PLANNING NMA-CHANGE LIST		
ID	Proposed Changes to plans that are 'Non Material'	Reason for 'Amendment'
A	Changes to Common stair towards compliance for general access where a clear landing needs to be provided and to accommodate smoke control. Circulation area and internal doorway to stairs rearranged to adapt corridor aisle. Stairs, structurally stacked for construction leading towards the corridor or lobby next to the stair being provided with a smoke vent and a store area provision on ground level. Rearrangement in plan due to the above visible on the Northwest facade. Window openings, adapted to suit mentioned changes/rearrangement.	Compliance towards Building Regulations, Part-K-Protection from falling, collision and impact and Part-B-Fire safety
B	Changes to Communal lifts and stairs towards compliance for firefighting where a firefighting shaft is required as the building is over 18m and to accommodate smoke control and building services. Circulation area internal doorway to stairs and clear landing for lifts rearranged to adapt corridor aisle. Stairs, structurally stacked for construction leading towards a vertical smoke shaft that opens at roof level with rationalised comm

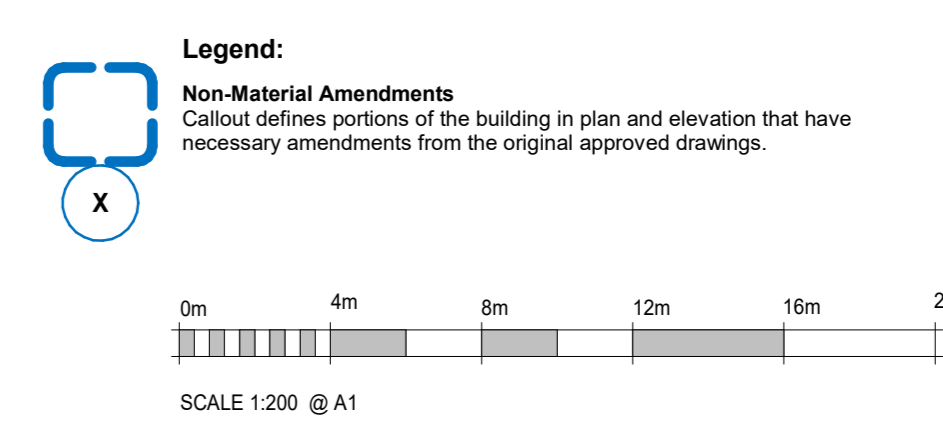
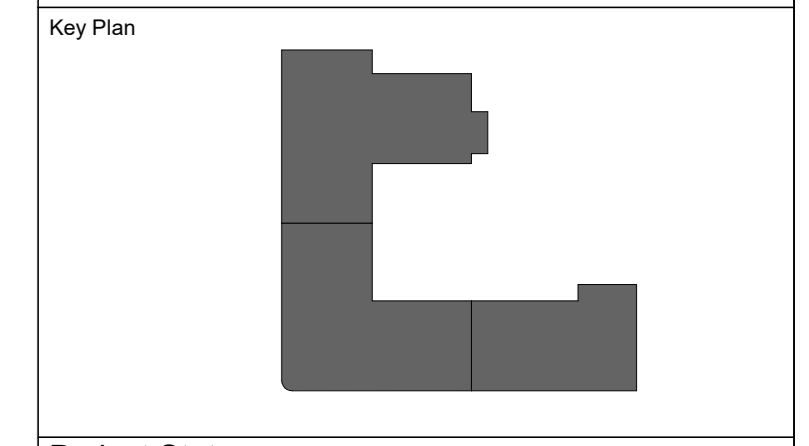
C	Changes to communal roof gardens (landscaping) including change of barrier type (railing) from glazed balustrade to counterbalance metal railing.	To contribute positively towards biodiversity via balance of soft and hard landscaping schemes including provisions for bird and bat boxes, whilst maintaining overall uniformity for railing type.
D	Removal of photovoltaic (PV) cells on the roof	PV was not required as Part L requirement was met using Exhaust Air Heat Pumps.
E	Relocation of Substation and provision for Generator in allocated space.	Provision for separate secluded area for generator
F	Changes to provide new location for UKPN Substation	Provision for future relocation for UKPN Substation
G	Changes to ground level Cycle store to accommodate building services plant rooms including removal of two openings with rearrangement of the remainder openings.	Provision towards Building Services, Secondary LV switch room and Corris room.

H	Changes to ground level Cycle store to accommodate building services plant rooms including removal of two openings with rearrangement of the remainder openings.	Provision towards secure access and splitting into 4 small bin stores to comply with recent update of having maximum 8 large (1100lbs) receptacles within.
J	Removal of Cycle store area and Bin store area at ground level, including external door in cycle store area towards provision to accommodate building services plant room including clear vehicular access towards undercroft parking.	Provision towards Building Services, Primary LV switch room and vehicular access towards undercroft parking.
K	Changes to ground level facade including removal of two openings to accommodate communal letter boxes with rearrangement of the remainder openings with provision for accessibility.	Provision towards communal letter boxes
L	Removal of undercroft parking entrance/exit at ground level towards provision for Relocation/Retainment of existing UKPN Substation, whilst adding double doors as per change ID C-05.	Provision towards single point of entry/exit for undercroft parking and towards relocation/retainment of existing UKPN Substation mentioned in change ID-E

M	Changes to ground and first floor level, Common stair for means of fire escape and to accommodate smoke control to circulation area. Circulation area and internal doorway to stairs rearranged to adapt corridor aisle. Stairs, moved away from corridor aisle leading towards provision for an external smoke vent at first floor level. Rearrangement in plan due to the above visible on the Northeast facade. Ground level escape door, adapted to suit mentioned changes/rearrangement.	Compliance towards Building Regulations, Part-B-Fire safety.
N	Changes to ground level Cycle room and adjacent Store to replace provision for Cycle store area as per change ID C-09 via consolidation. Rearrangement in plan due to the above visible on elevations.	Provision towards replacement of removed cycle store mentioned in change ID-J.
P	Changes to Communal lift and stairs towards compliance for general access where a clear landing needs to be provided and to accommodate smoke control and building services. Circulation area internal doorway to stairs and clear landing for lifts rearranged to adapt corridor aisle. Stairs, structurally stacked for construction leading towards covered and enclosed stair at roof fourth floor level with rationalised communal entrance/exit. Rearrangement in plan due to the above visible on elevations.	Compliance towards Building Regulations, Part-K-Protection from falling, collision and impact, Part-B-Fire safety and Provision for stair enclosed/walkway that is directly covered.

Q	Changes to ground level Bin store arrangement to replace Bin store as per change ID C-09 via consolidation and enlargement to provide building services plant room. Rearrangement in plan due to the above visible on elevations.	Provision towards replacement of removed Bin store mentioned in change ID-J and provision for BCW Tank room.
R	Changes to ground level openings, facade screens from circular pattern metal screens/vents to vertical extruded aluminium flats metal screen that match the railing type, including removal of one opening that clashes structural column on the comet way elevation.	To maintaining overall architectural uniformity and structural framing.
S	Removal of Green Wall as they do not comply with fire safety regulation 7(2).	Regulation 7(2) requires all residential blocks with top storey heights over 18m to have all materials which become part of an external wall or specified attachment (e.g. balconies) to achieve class A2-s1, d0 or class A1, except for materials which are exempt as per regulation 7(3). Additionally, membranes used as part of external wall construction above ground should achieve a minimum of class B-s3, d0.

T	Changes to storage area, rearrangement towards desired storage required.	Provision towards desired storage required.
U	Discrepancy error on Comet way elevation whereby two window openings depicted would not have been located on the fifth-floor level plan as these would intrude privacy for the bathrooms.	Discrepancy error
V	Removal of single window, recessed brick reveals on the Northeast elevation.	The recessed brick reveals is towards the left of a single pane window for levels 1-4, whilst it changes to a double pane for level 5. To maintain architectural uniformity, we have detailed a constant double pane window for all levels.
X	Private path on western site boundary	For Façade maintenance MEWP access.
